**Guy Smith Stadium Improvements Phase 1  
Addendum No. 02**

<b>Project Name: Guy Smith Stadium Improvements</b>	<b>Project No.:</b> RFP#23-24-12
<b>Prepared By: Mark Nottingham</b>	<b>Date:</b> 08-30-2023

DESCRIPTION: Clarifications to Bidders  
PROJECT: 23-0176  
PROJECT NO. Guy Smith Stadium Improvements  
DOCUMENT DATE: 08/29/23

### **SHEET C101A – SITE PLAN PH. 1**

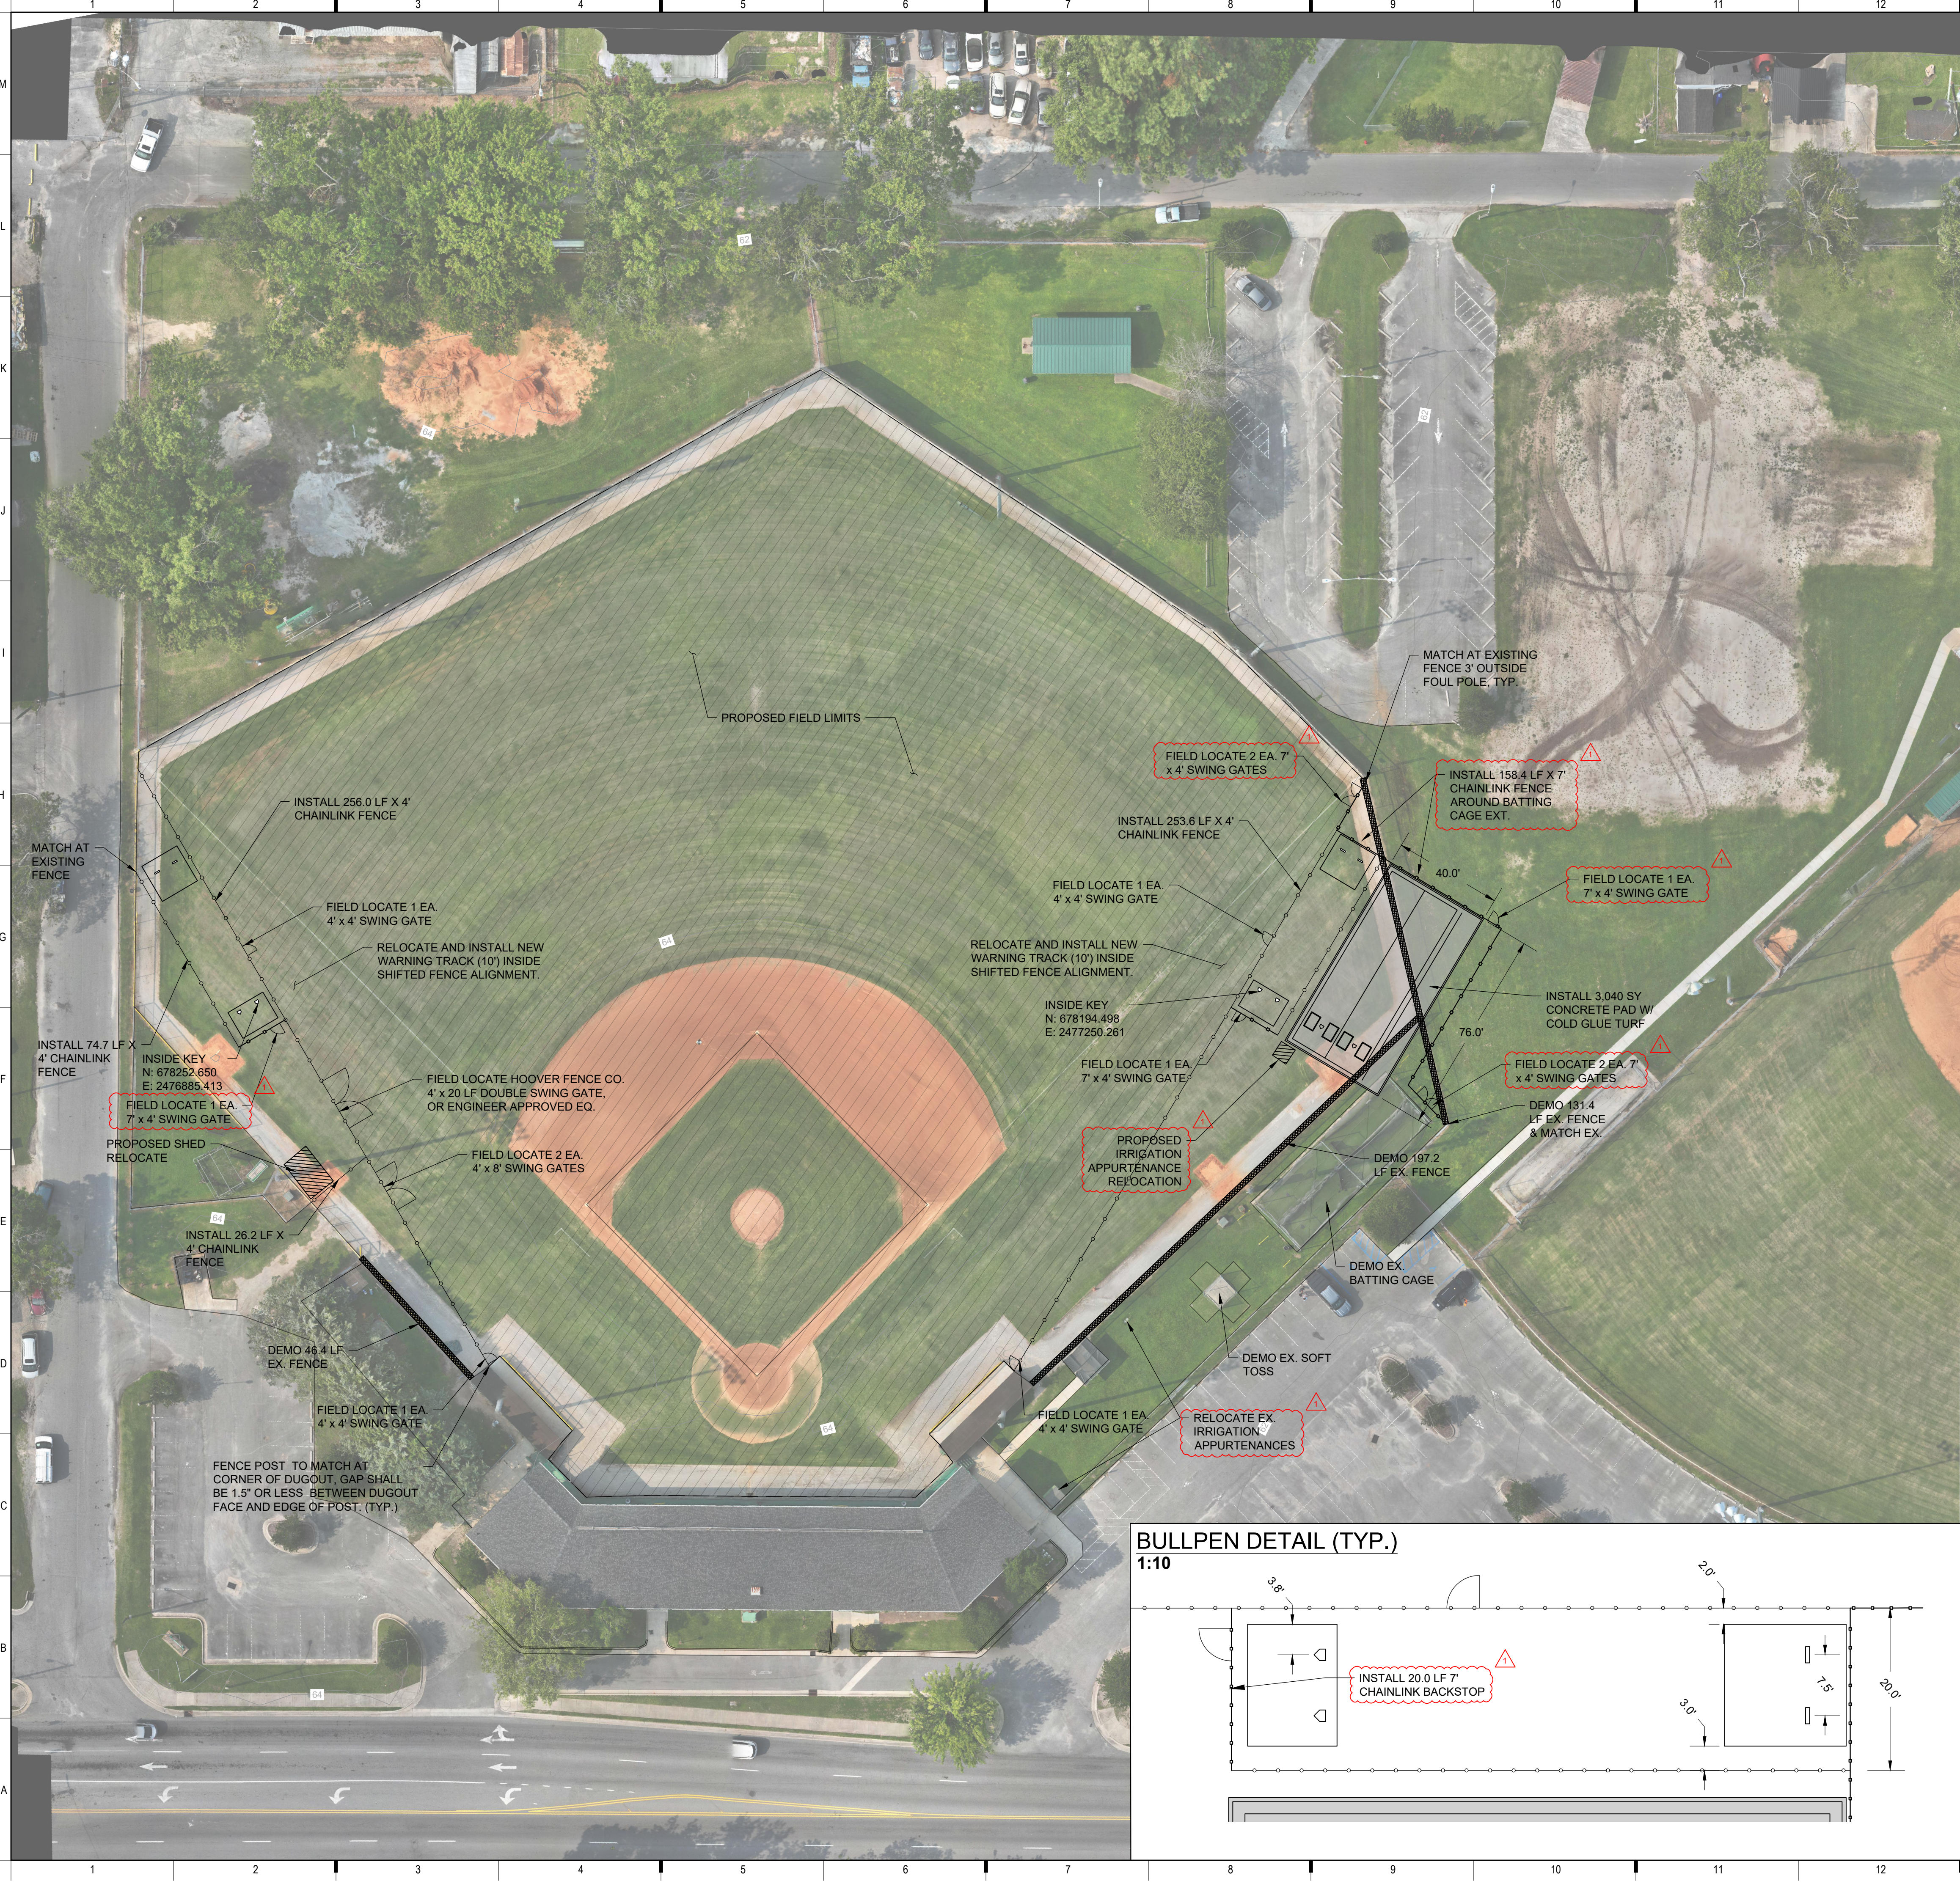
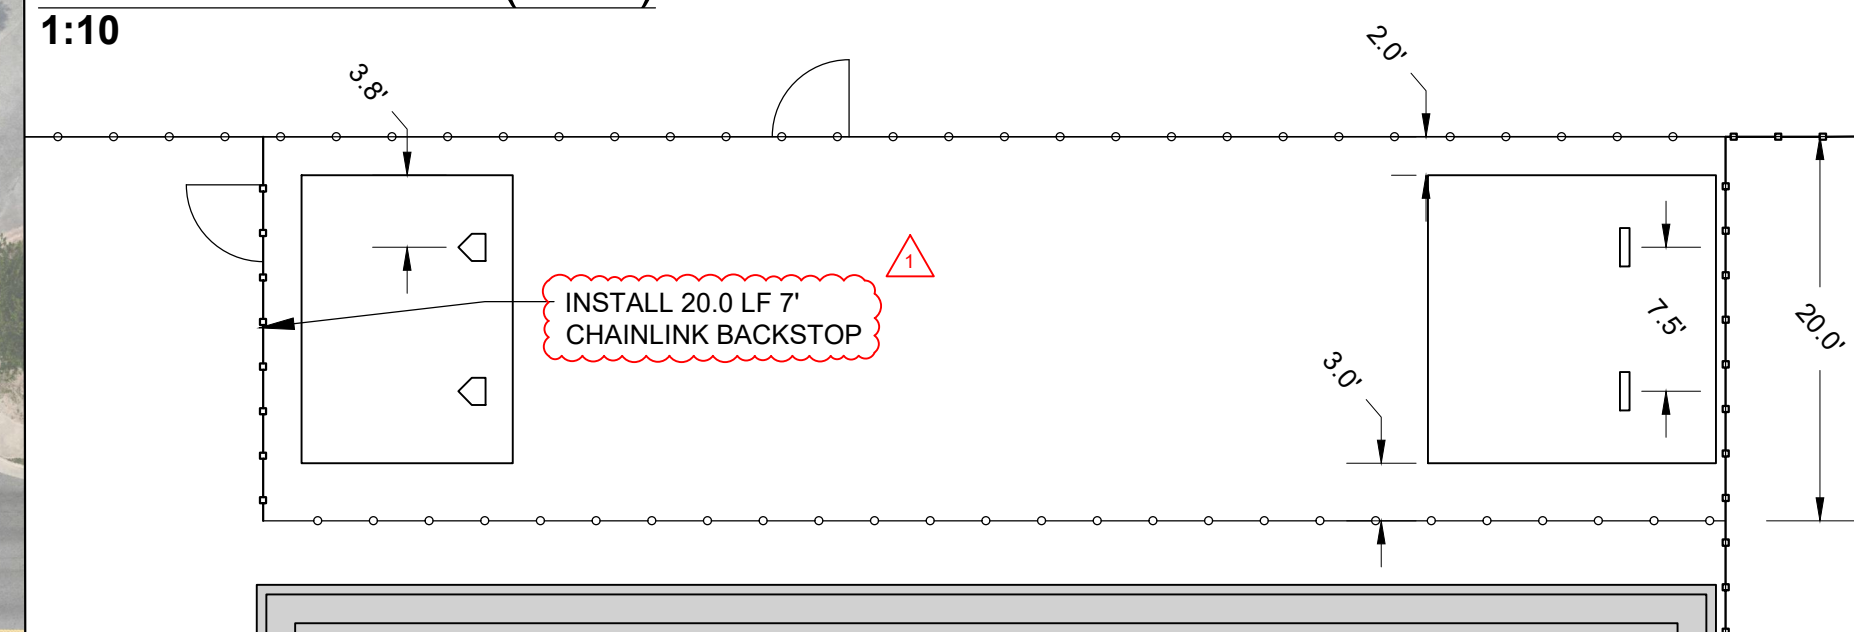
1. Revised any callout referencing the west exterior fence to say 7' (contractor to field verify and match). (Item #1)
2. Added callouts for west irrigation appurtenance relocation in preparation for Phase 2 concrete work. (Item #1)
3. Revised bullpen backstop fence height callouts for more cohesive site fencing plan. (Item #1)
4. Revised and added site plan notes to include references for fencing heights/specifications. (Item #1)
5. Revised any callout referencing the west exterior fence to say 7' (contractor to field verify and match). (Item #1)
6. Added callouts for west irrigation appurtenance relocation in preparation for Phase 2 concrete work. (Item #1)
7. Revised bullpen backstop fence height callouts for more cohesive site fencing plan. (Item #1)
8. Revised and added site plan notes to include references for fencing heights/specifications. (Item #1)

4' WIDE x 7' DOUBLE CHAINLINK SWING GATE  
NTS

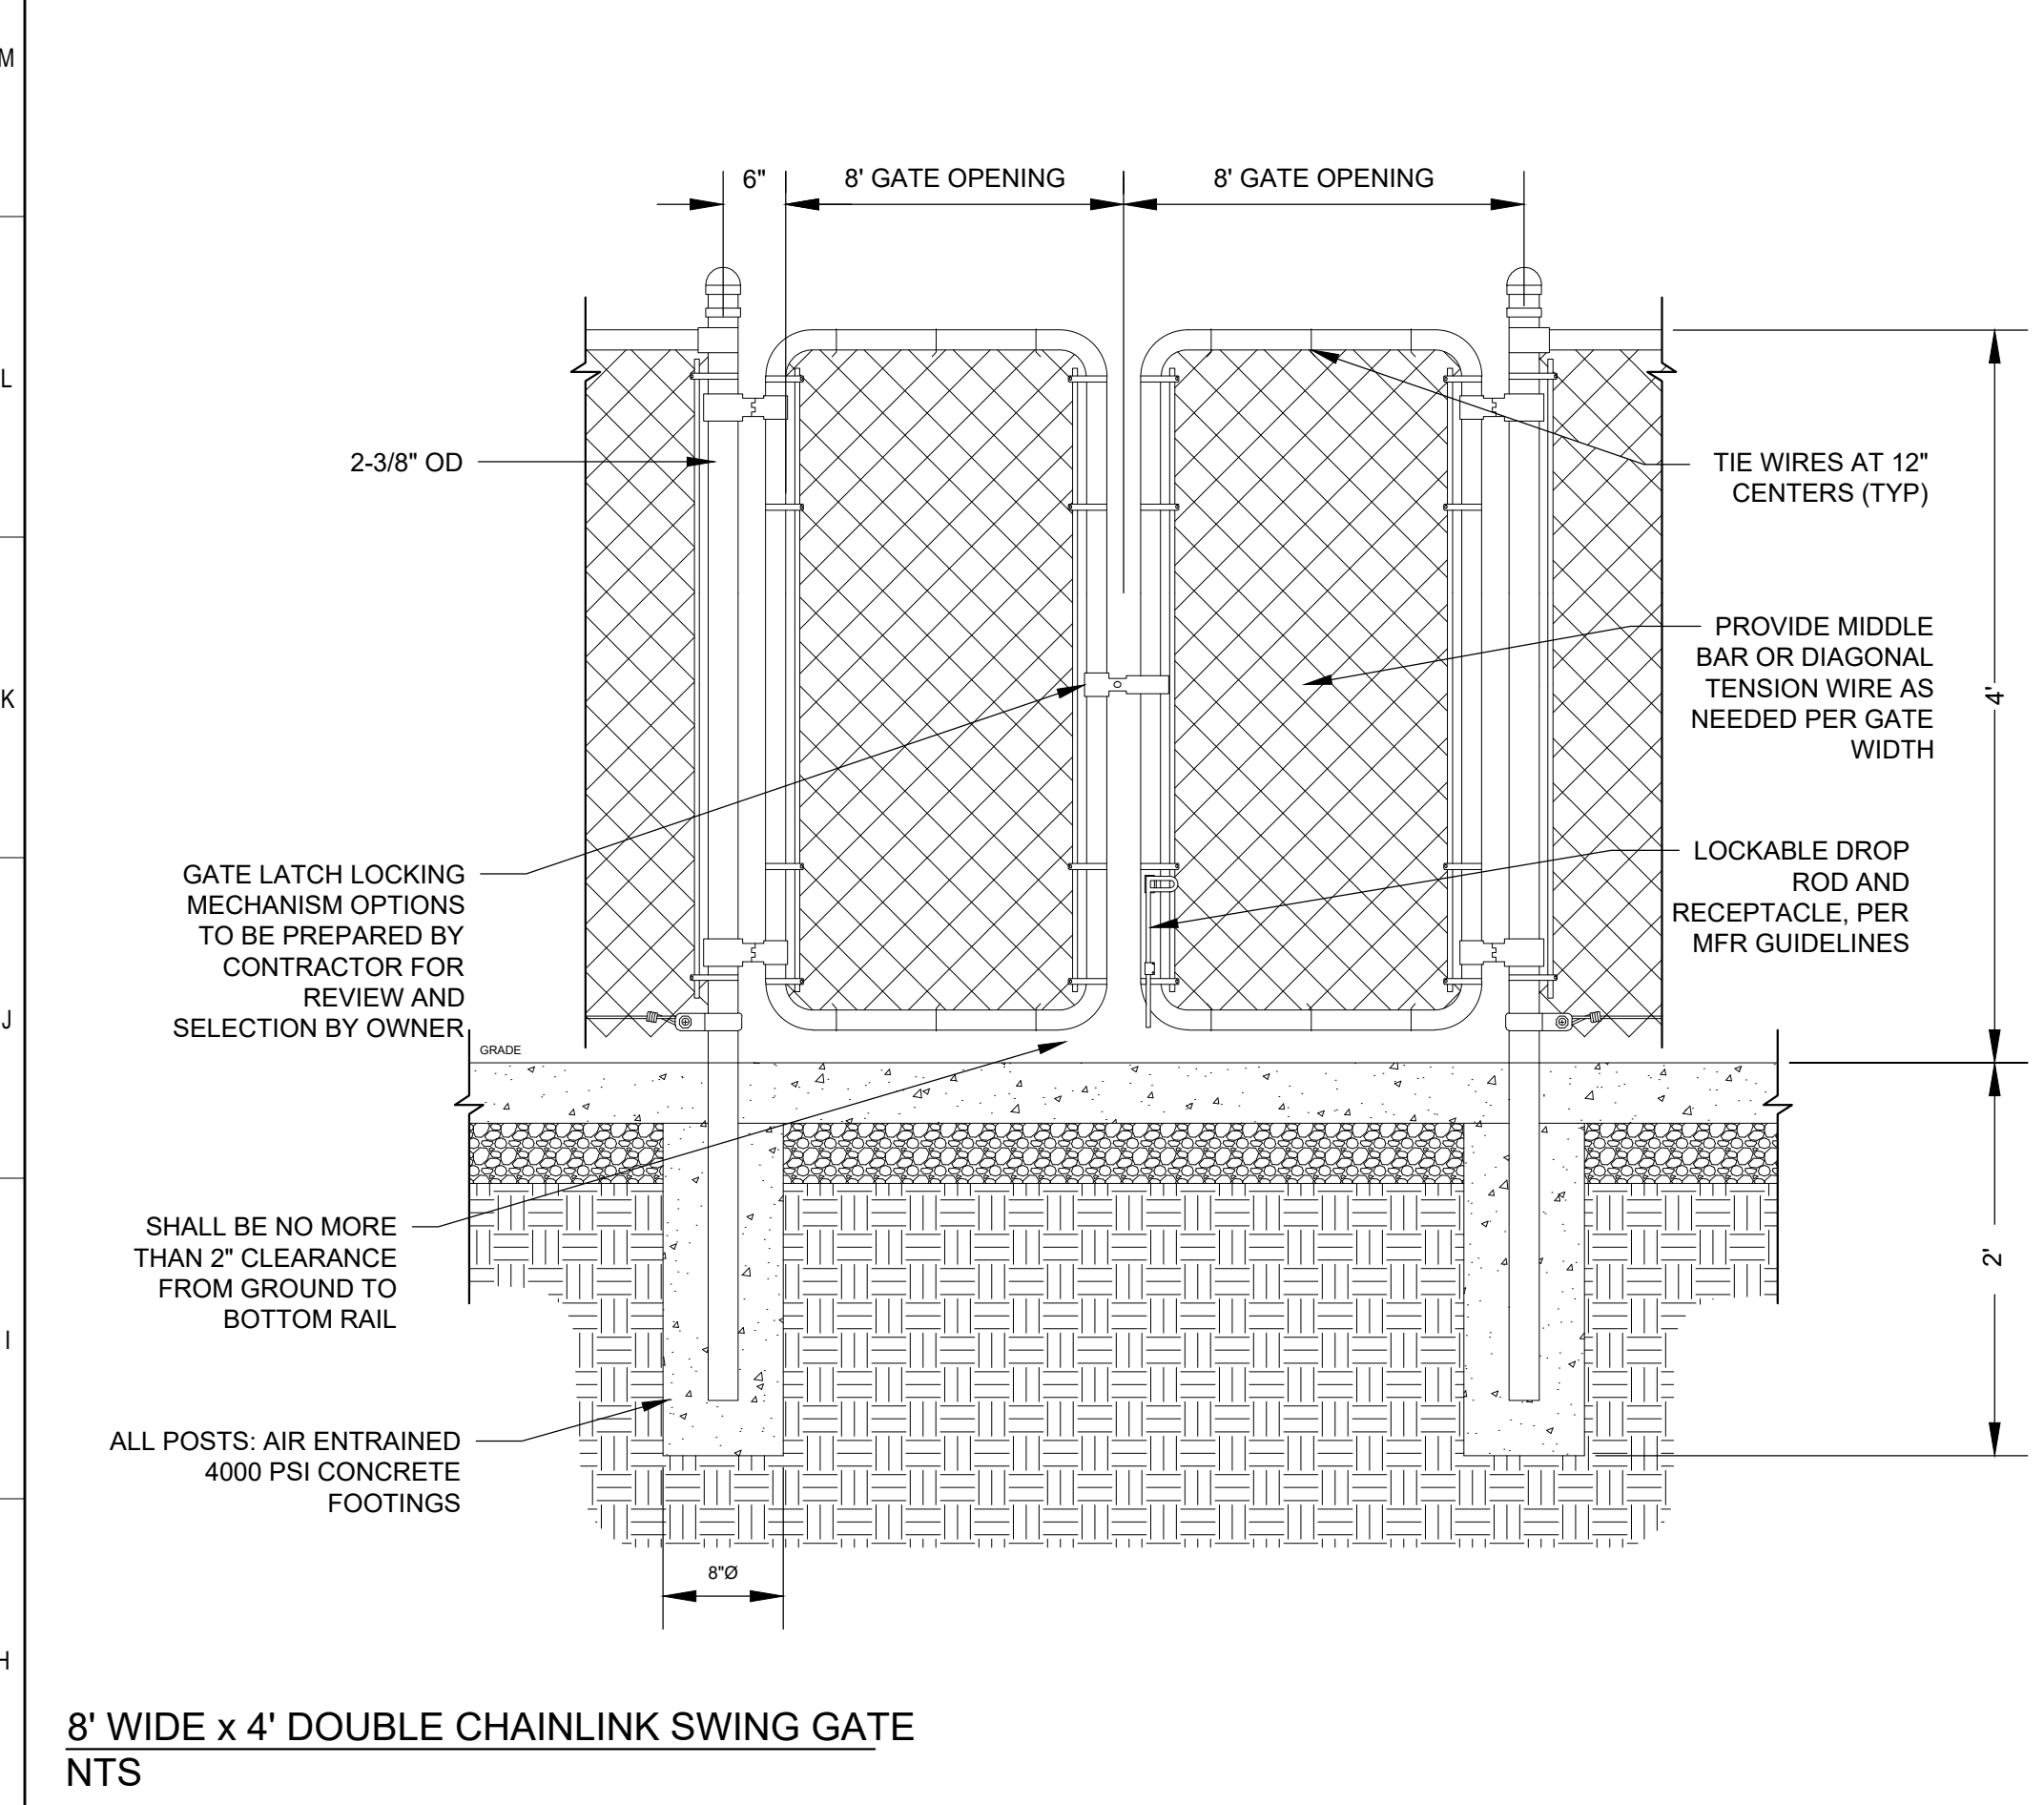
#### DETAIL – 4' WIDE X 7' DOUBLE CHAIN LINK SWING GATE

1. Removed vinyl coating callout, upgraded post and footing sizes due to privacy screen. (Item #1)
2. Removed any details referencing 8' fence, all fence on site is now either 4' or 7' tall. (Item #1)
